MONITORING REPORT
2022 (Year 4)

MAJOR HILL STREAM AND WETLAND MITIGATION SITE

Response to Monitoring Year 4 (2022) DMS Comments

Major Hill Mitigation Site (DMS #100015)
Cape Fear River Basin 03030002, Alamance County
Contract No. 100015

Dwn. By: KRJ	FIGURE 2
Date: Nov 2022	
Project: 17-009

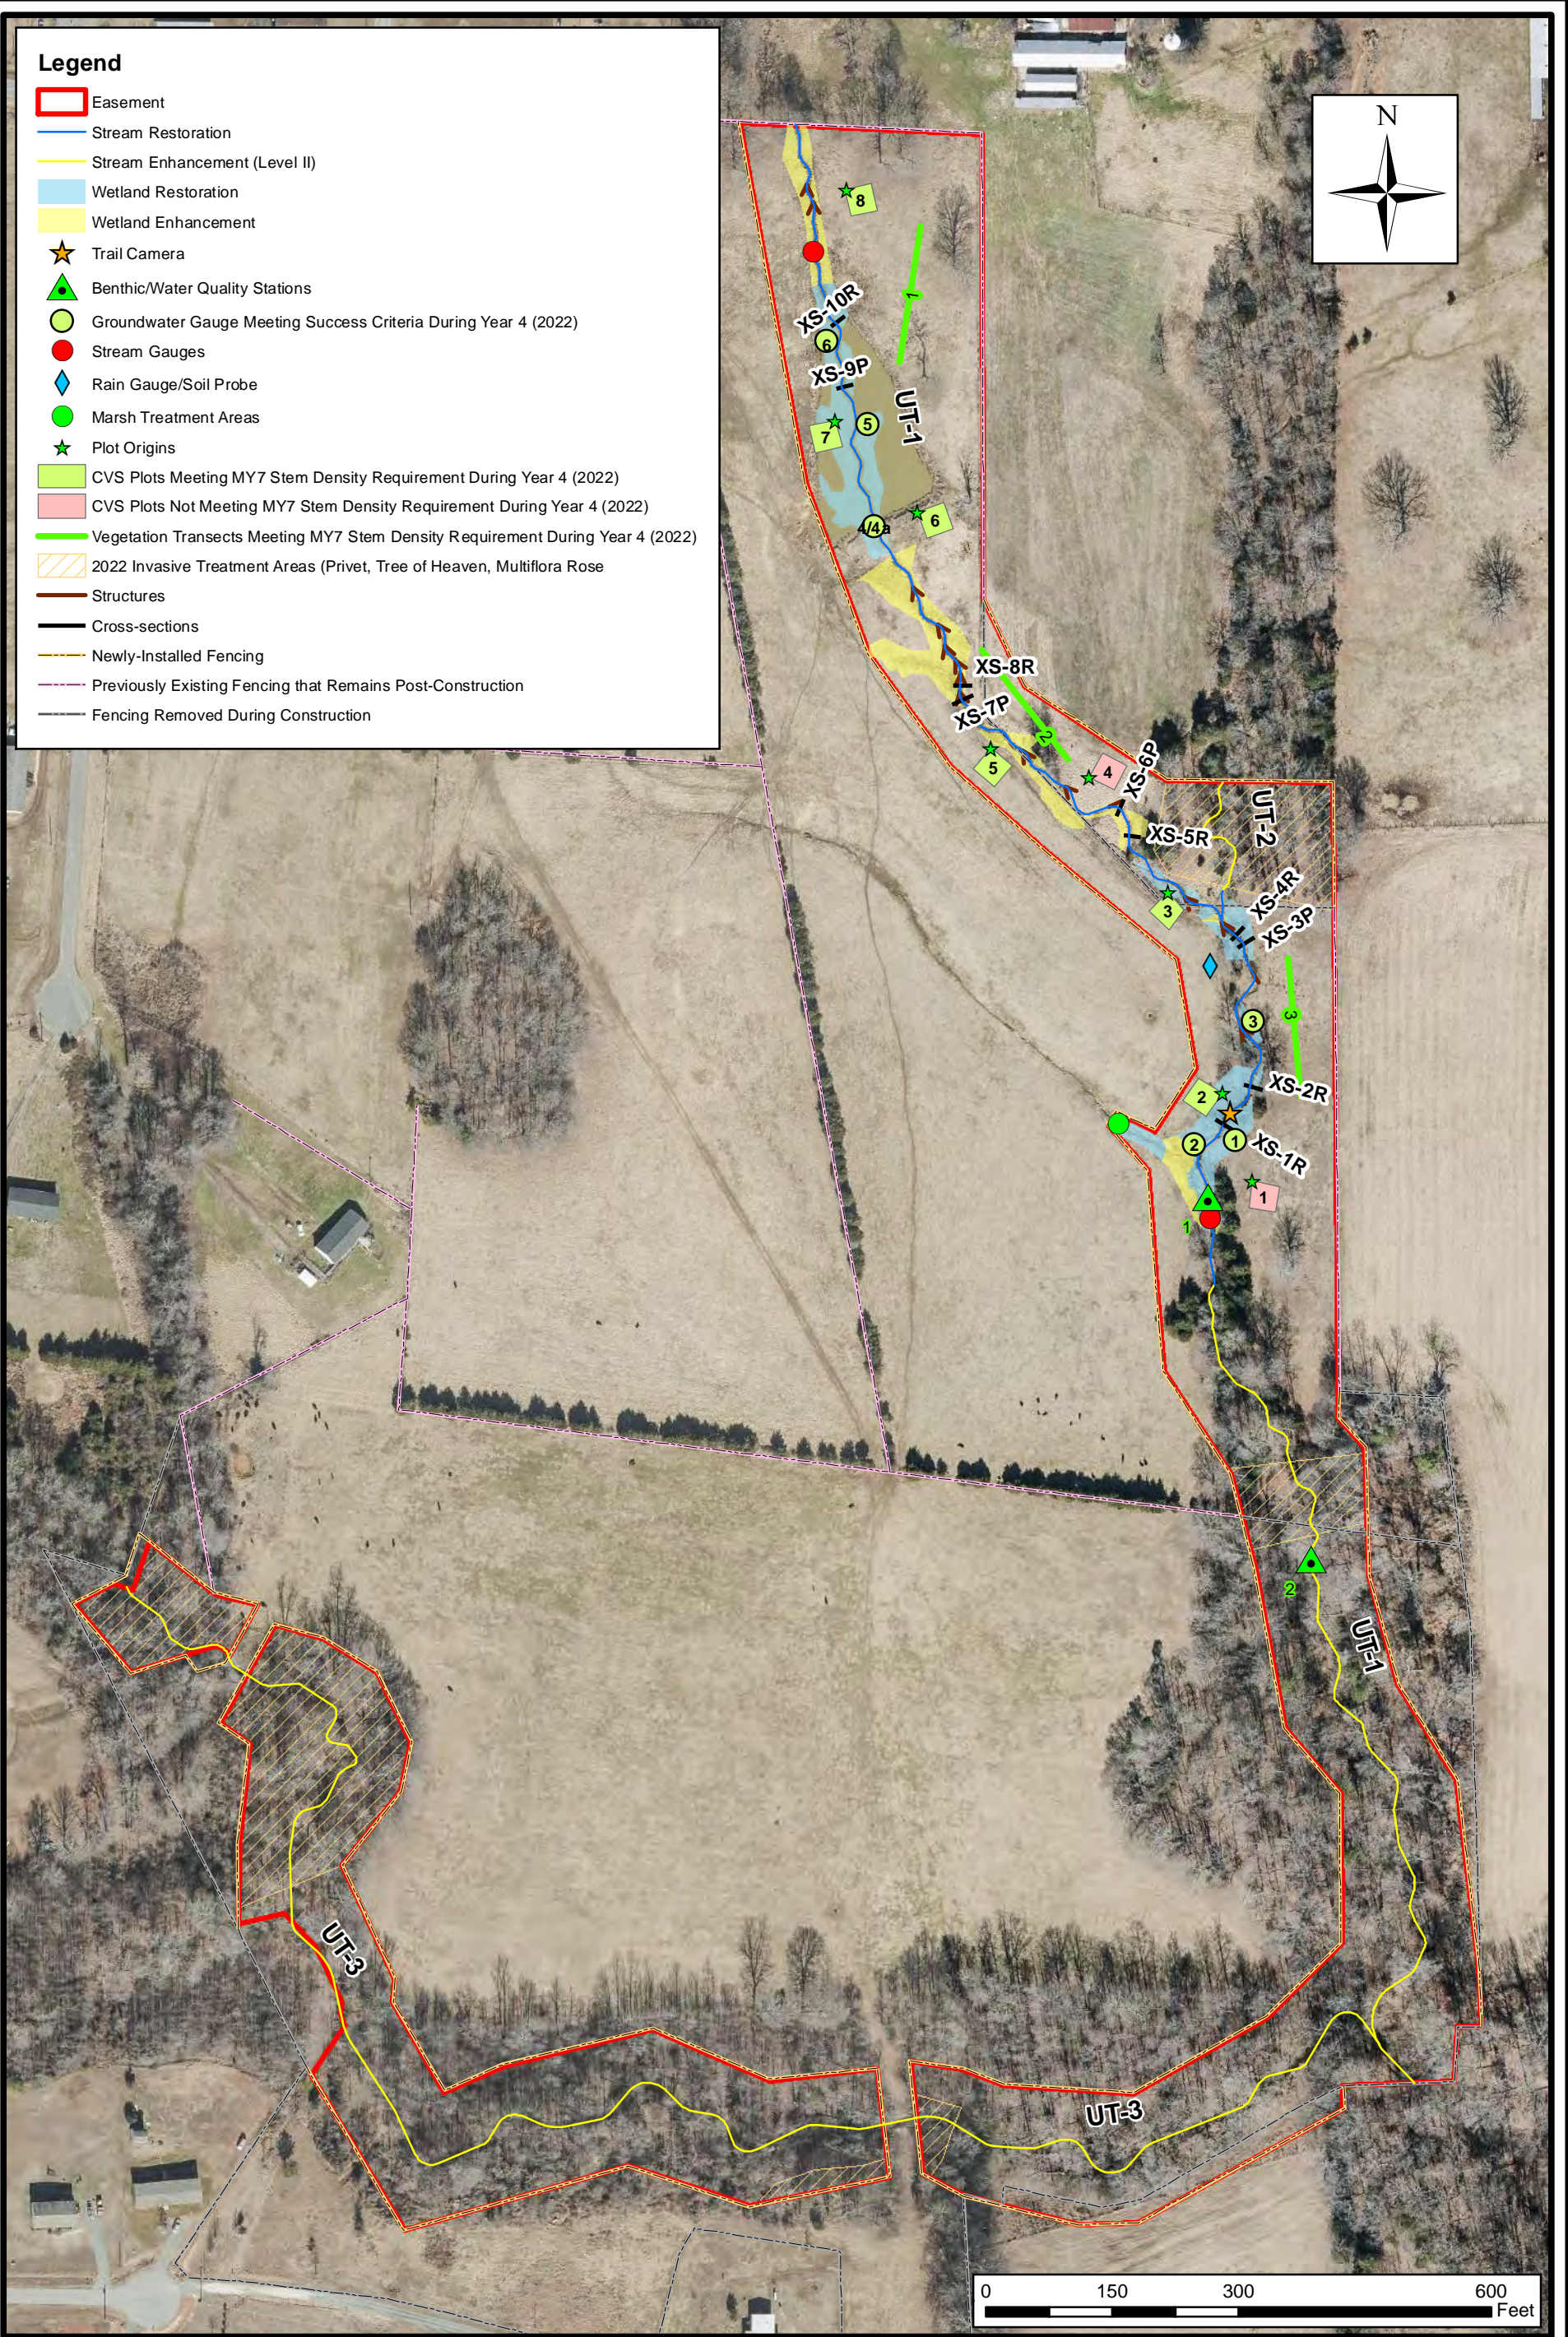
1. The report indicates invasive species treatment in 2022 but no area of concern is noted on the CCPV or in the visual assessment table. Please verify the visual assessment was correct at the time of report submission.
[Response: The visual assessment is correct. Footnote 4 of Table 6 \(Vegetation Conditions Assessment states,](#)

["The list of high concern species are those with the potential to directly outcompete native, young, woody stems in the short-term \(e.g. monitoring period or shortly thereafter\) or affect the community structure for existing, more established tree/shrub stands over timeframes that are slightly longer \(e.g. 1-2 decades\). The low/moderate concern group are those species that generally do not have this capacity over the timeframes discussed and therefore are not expected to be mapped with regularity, but can be mapped, if in the judgement of the observer their coverage, density or distribution is suppressing the viability, density, or growth of planted woody stems.](#)

[The current level of invasive species on-site do no meet the criteria of "high concern" nor "low/moderate concern." Species treated are sporadic in nature, and do not pose a threat to young woody stems in the short-term nor suppressing the viability, density or growth of planted woody stems.](#)
2. Water quality summary data is included in the report, but no data was submitted in year 4; if applicable please provide missing data.
[Response: Water quality data is measured onsite, using digital meters, and readings are recorded by hand. Data is then entered directly into Table 9 of the document, and therefore, no raw data exists.](#)
